Product Change Notice (PCN)

PCN Number: **PCN-0451201R-02**

Product(s) Affected: **PJ-056**

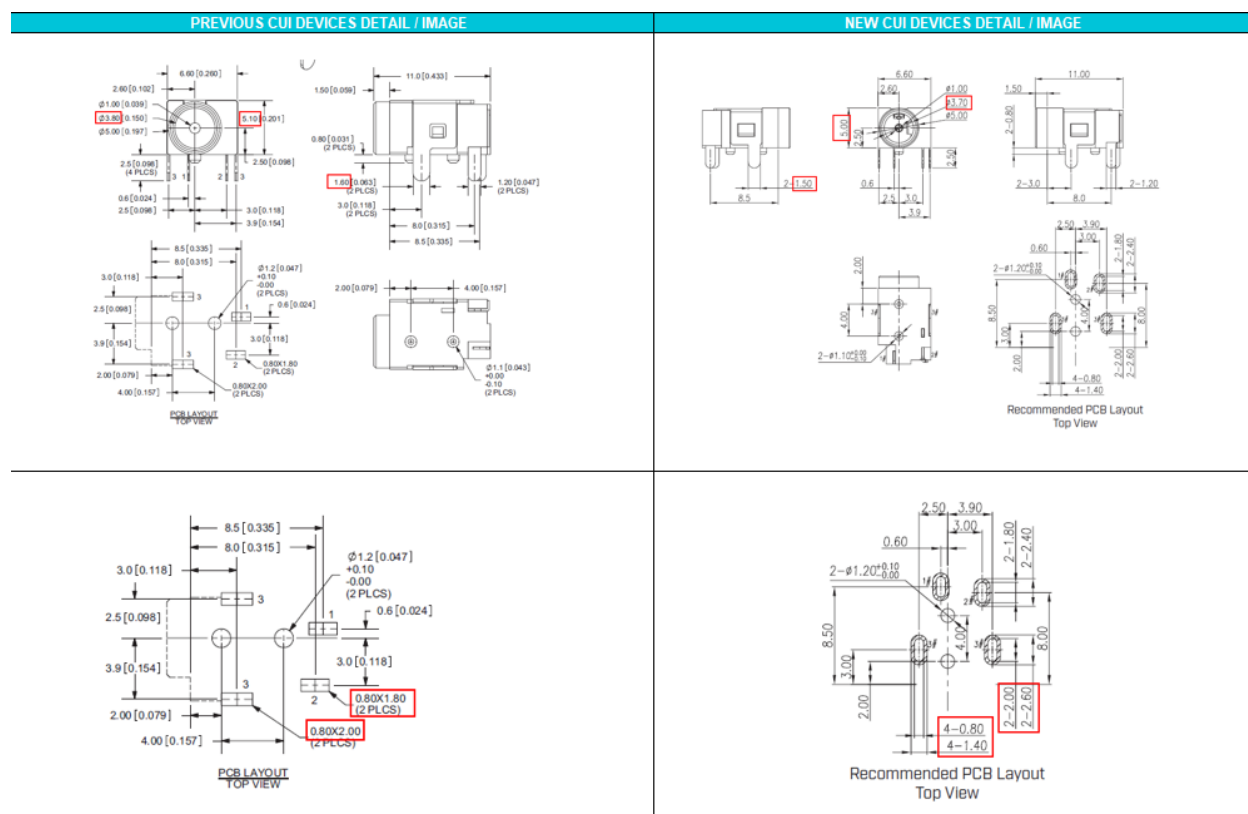
Description of Change: **Minor Housing and Material Difference. See image Below**

PREVIOUS CUI DEVICES DETAIL / IMAGE			NEW CUI DEVICES DETAIL / IMAGE		
	MATERIAL	PLATING			
center pin	brass	tin			
terminal 1	brass	tin	DESCRIPTION	MATERIAL	PLATING/COLOR
terminal 2	copper alloy	tin	terminal 1	brass	tin
terminal 3	copper alloy	tin	terminal 2	copper alloy	tin
plastic	PA66		terminal 3	copper alloy	tin
			housing	PBT (UL94V-0)	black
